ADDENDUM NO. 5

Project: Missoula Garden City Compost Improvements Project

Date of Addendum: March 18, 2025

Base Slab Construction/Expansion Joint 2
NO SCALE

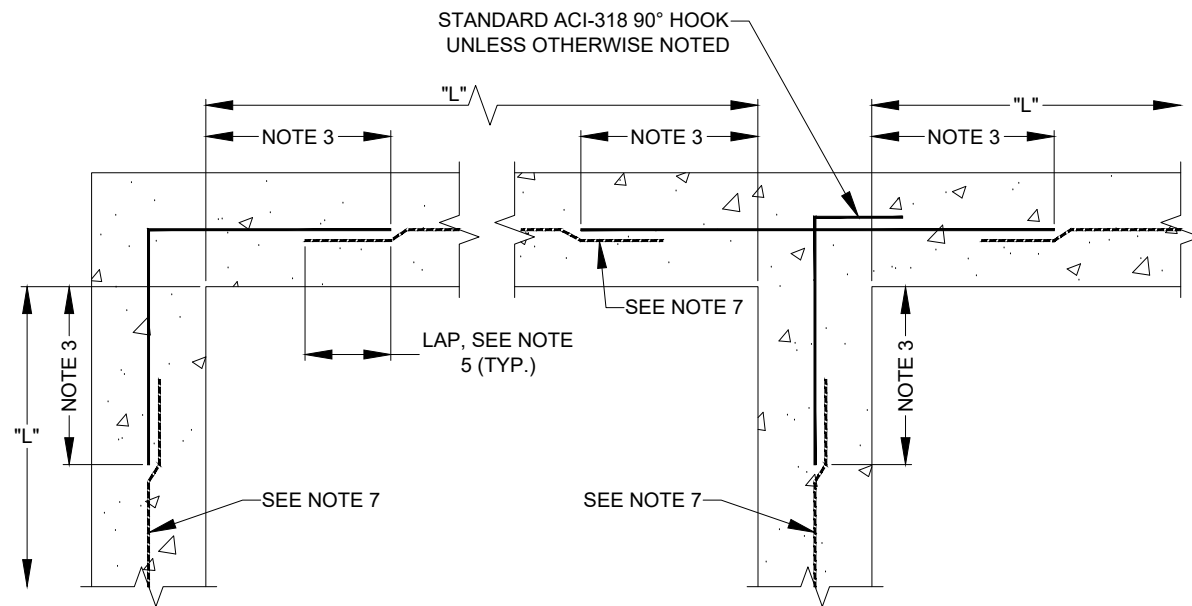
- Sheet S-4, Detail 2; revise Base Slab Construction/Expansion Joint
- Sheet S-6, Detail 4; eliminate 2-layers polyethylene sheeting;
- Sheet S-7, Detail 3; revise rebar placement in compost slab;
- Sheet S-9; revise rebar spacing, joint spacing and Note 1;
- Sheet S-10; revise rebar spacing and joint spacing;
- Sheet S-11; revise joint spacing;
- Sheet S-12, Detail 1; eliminate 2-layers polyethylene sheeting;
- Sheet S-16, Detail 4; eliminate 2-layers polyethylene sheeting
